General Service Bulletin

Rockwell water cooled AFDD liquiflow 1.5 PIC board field repair on 350, 450, 600, 750 & 1000 HP drives (CVHE, CVHF, CVHG Units)

ORDER No.: **CVHE-SVB10A-EN**

DATE: October 2002

Figure 1: Close-up View of U2 Location

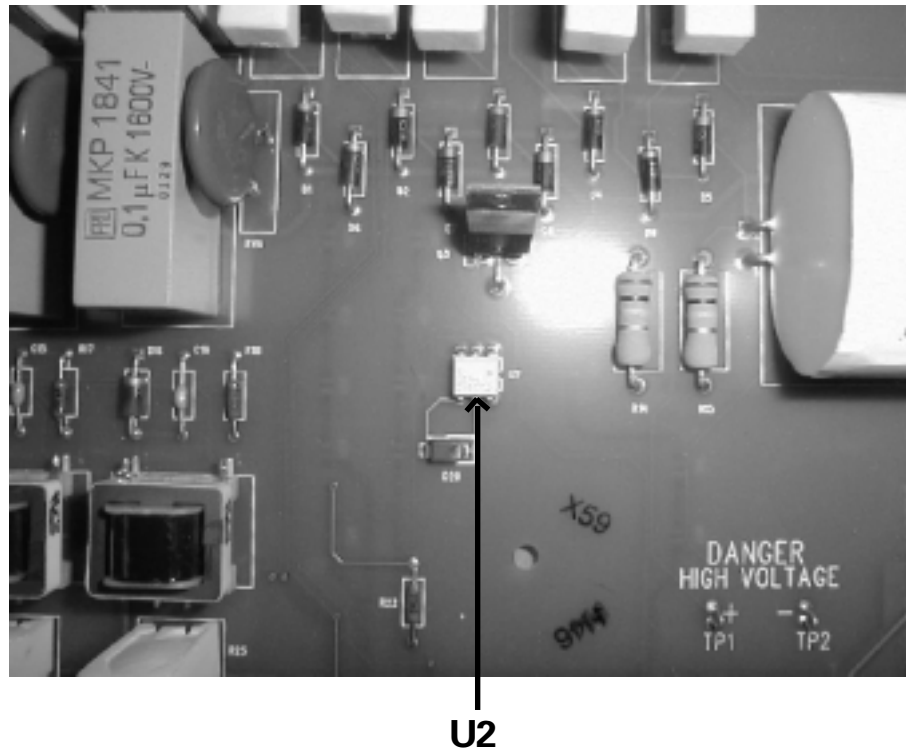
It has been determined that in a few isolated instances, that when high input line voltage conditions exist along with variations with board components on the Pic board component failures on the board may occur due to voltage spikes. The spike has in some cases damaged components causing failure of the Pic board.

When you look at the board, (Figure 1 and Figure 2), there is a component called a opto-coupler. It is a small square white part approximately ¼" square.

Removal of the optocoupler referenced as U2 on the following PIC PCB assemblies is required for proper operation:

The optocoupler is located in the center of the board, as shown in the following pictures:

If the unit has not been started, this opto-coupler needs to be removed. If the unit has already been started it does not have to be removed. The opto-coupler switches a bleeder resistor in and out of the circuit. When we remove it we disable the function so the bleeder resistor is always in the circuit to dampen short voltage spikes at startup.

No functionality is sacrificed by removal of the U2 coupler. All future production Pic boards will have the U2 coupler removed. Pic boards that have been revised will have a revision of Rev 05 shown on the board. Boards that need to have the U2 opto-coupler removed will show a Rev 04 on the board.

Figure 2: Full view of PIC Board Assembly Showing U2 Location

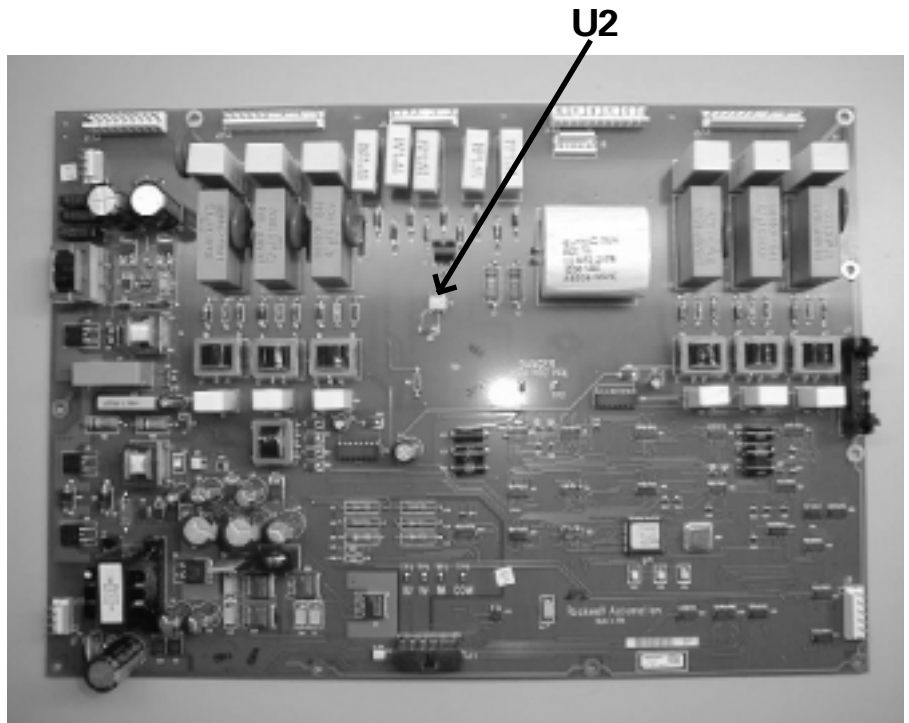
2. In this retrofit, the PCB can remain mounted while performing the necessary procedures. However, utilize proper grounding procedures when working with the Printed Circuit Board.
3. Locate PIC board on respective drive (please reference manual for board location).
4. Remove the component U2, by clipping each of the six (6) pins on the topside at the board level.
5. Verify that none of the remaining pins are able to short together.
6. Confirm all ribbon cables are connected properly and reapply power.
